Ogdensburg City School District

2023 Capital Outlay Project

FO 104-03 Area 3 Subbase

CHANGE ORDER CERTIFICATION

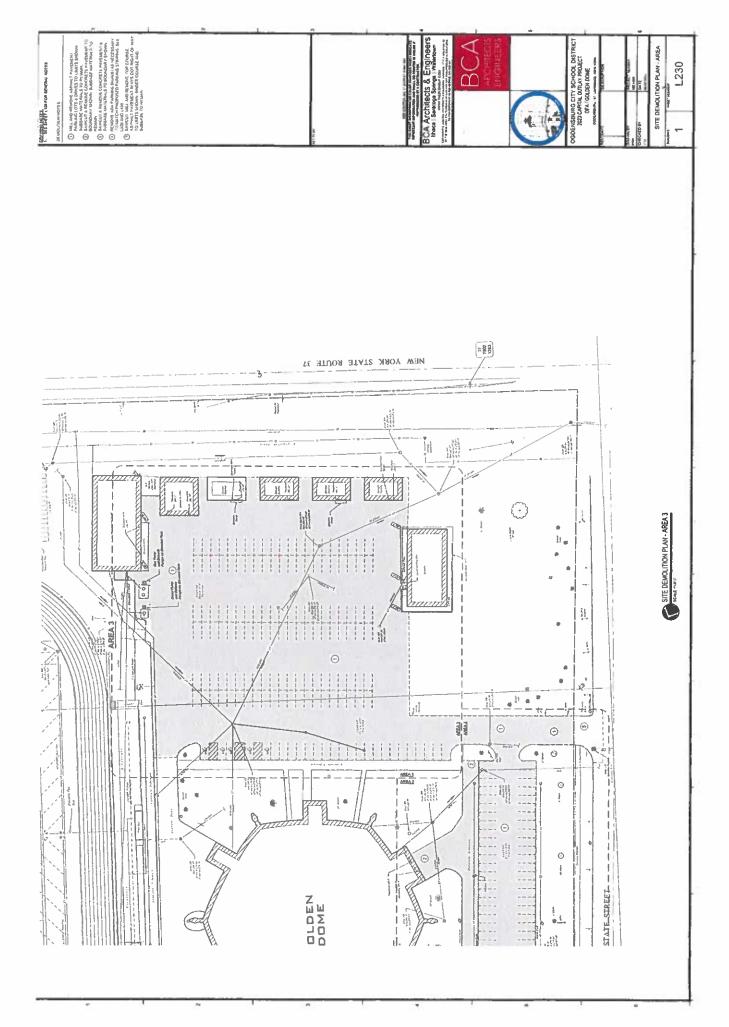
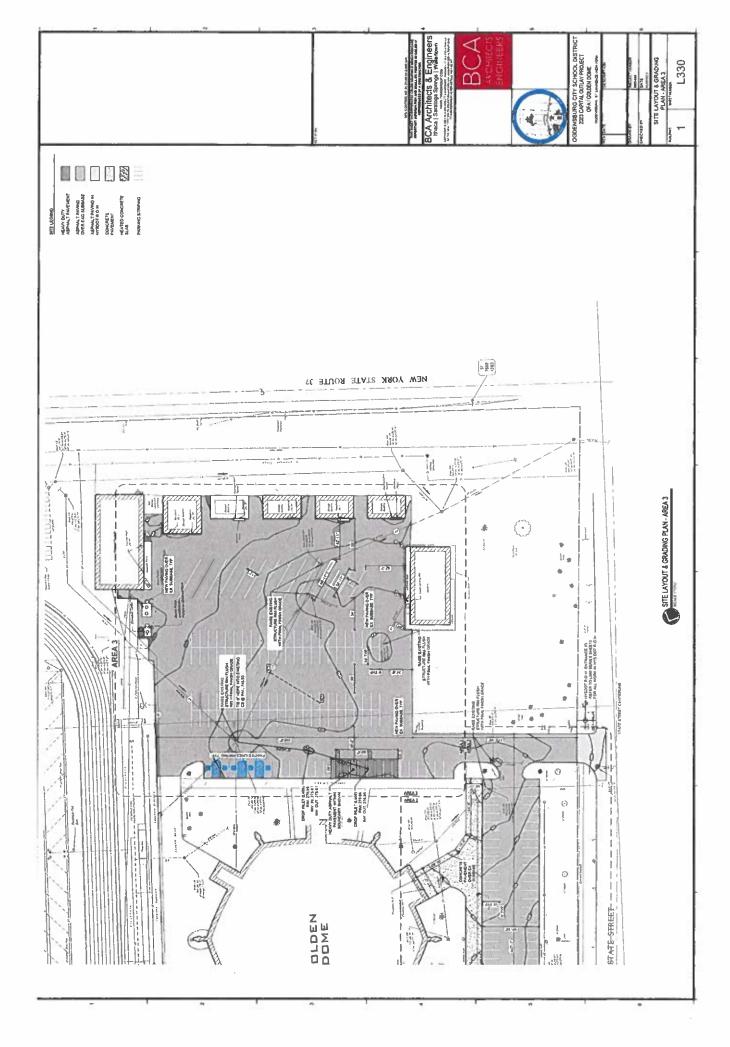
Α	General Contractor
В	Under the Capital Outlay Project, the existing parking lot noted in Area 3 was scheduled for reconstruction as per Contract Drawings L230 and L330.
С	During removals, the General Contractor discovered a wet area of subbase in the southeast corner of the parking lot that was unsuitable to support the new pavement. As such, the wet material was removed and stabilization fabric installed to bridge the area prior to installing new compacted select stone.
D	Add to provide all labor, materials, and equipment to box out and replace 40'x80' area of wet subbase with 12-inches of compacted selected stone & stabilization fabric at Area 3 adjacent to Storage Building No. 1.

Following please find our proposal to perform additional undercut due to existing soil conditions. We boxed out the existing material to minus 12" add fabric and replace the existing material with type 2 stone compacted.

*Primary area Undercut 12" 40'x80' @ \$6.50/SF \$20,800

*A portion of the under-cut was still pumping so an additional 12'x40' area was undercut an additional 12" and type 2 stone was installed 480sf @ \$6.50/SF \$3,120
